DEVELOPMENT APPLICATION

PDPLANPMTD-2023/039889

PROPOSAL: Additions & Alterations (Single Dwelling)

LOCATION: 1 Kelson Place, Acton Park

Submission for - C3.6.1

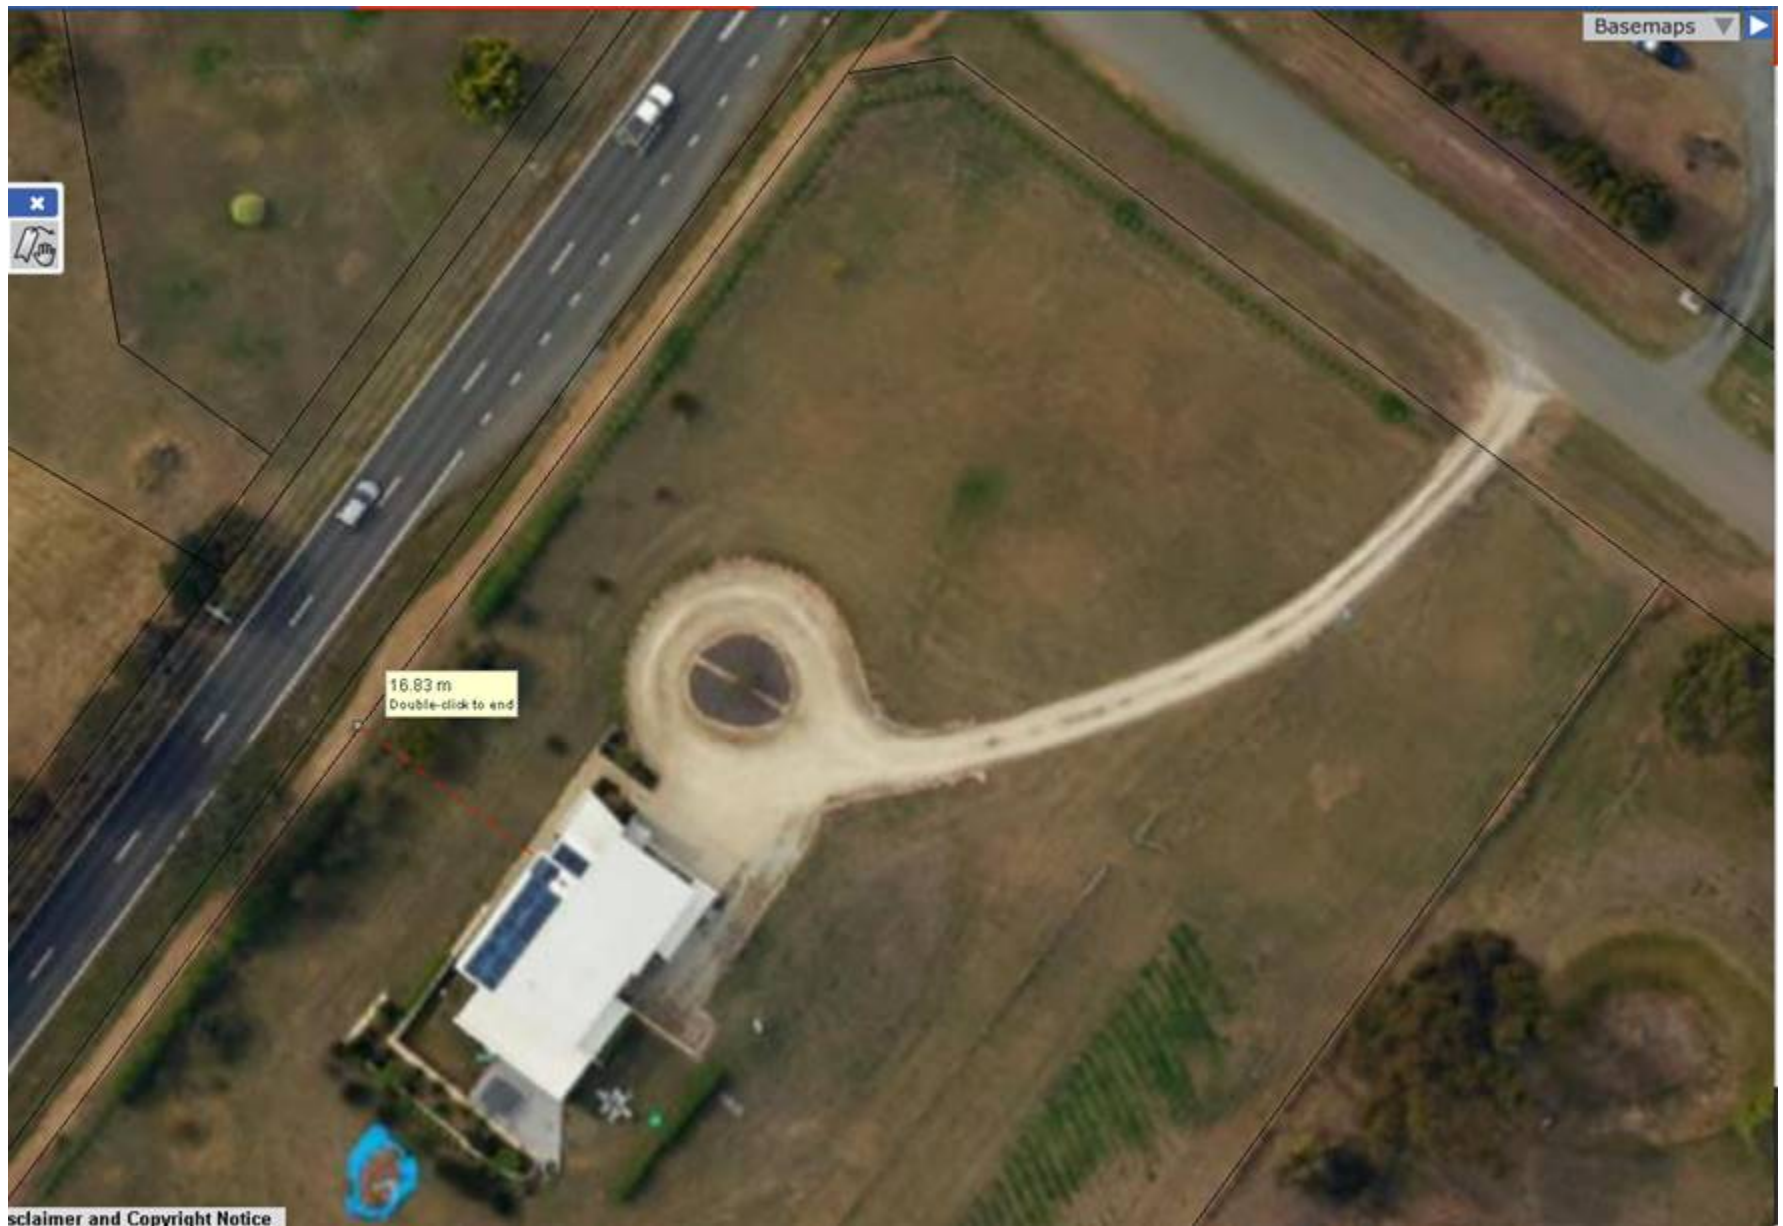
Please find attached updated plans and the below comment and images in response to your most recent RFI.

The proposed setback to Acton Road is 19.809m and is more than the neighbouring dwelling at 2 Kelson Place (approx. 16.82m) and 5 Kelson Place which also fronts Acton Road has a front setback of 14.84m to the Garage/outbuilding (wall length 12m). This indicates that the proposed setback for 1 Kelson place is not out of character for the area and will not result in significant bulk or scale when viewed from the street. The part of the proposed building that is less than 20m from the secondary frontage to Acton Road is single storey and Garage only, and therefore not considered a habitable space. Other habitable parts of the proposed building exceed the 20m minimum setback.
